Profile Park Power Plant
Planning Application SD21A/0167

Response to Request for
Clarification of Additional Information (CAI)

Document Control Sheet	
Document Reference	11069-D02
Report Status	Issue Copy
Report Date	May 2022
Current Revision	D01
Client:	GREENER IDEAS LIMITED
Client Address:	C/O Centrica Business Solutions, 1 Seapoint Building, 44-45 Clontarf Road, Dublin 3, D03 F4A7
Project Number	11069

Table 2-1 Material Palette and Selection Process

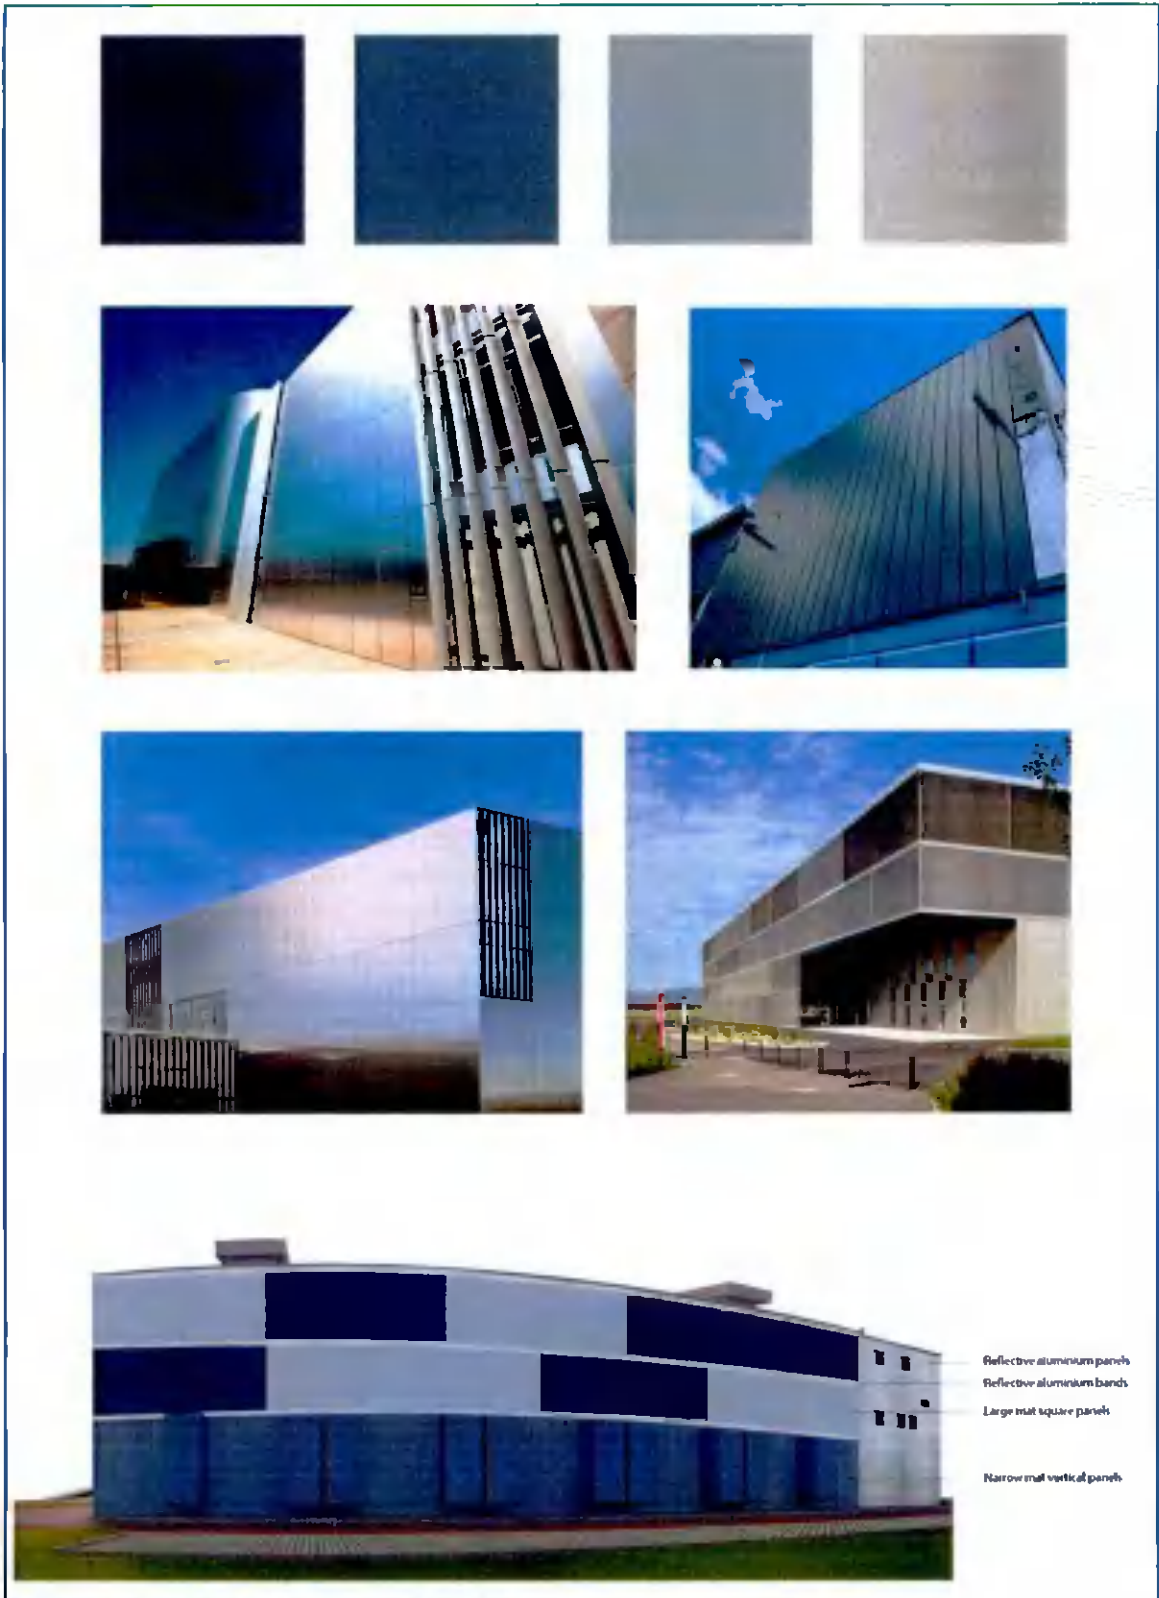
(i) detail of the design of the road facing north, east and south frontages. Whilst colour adds variety to the facades, the applicant is requested to add further detail to break up these frontages. The presence of landscaping is welcomed however it should not be relied upon solely to mitigate visual impact.

1(a)(i) - Based on the comments in the CAI relating to the adding of further design detail to the road frontage façade, in addition to just colour, it was clear that a greater consideration of context was required for the main façade treatment. A closer review of other buildings and structures within Profile Park indicated a considered departure from standard industrial premises. Using the same principles that had already been subtly applied (using dark and light tones to suggest regular solid and void) for breaking up the scale and massing, a more detailed tone and textural study was undertaken with the intention of generating a bolder and more effective architectural response.

The graphical process of this study is represented in Figure 2-1. The outcome of the study is the use of a series of broad horizontal bands of alternating dark and light tone blocks divided by narrow horizontal bands of aluminium cladding. These narrow bands of aluminium cladding then tie into a much broader use of the same material for the entire northern end of the main building. The use of this high quality semi-reflective finish is threefold. It is intended to break up the perceived massing and length of the main building by using an alternate treatment to the southern and central façade; it expresses a high-quality finish that is not necessarily typical of industrial buildings but is typical of those within profile park including the adjacent data centre, and it provides the opportunity for reflectance of the sky and proposed landscaping treatment which is rich in tree planting. All of these attributes can be seen in the updated photomontage set, particularly from the nearest VP1, VP2, VP3 and VP4 locations. In all instances, it is considered that the design approach is more appropriate to this setting and although architecturally bolder, it will not result in increased visual impacts.
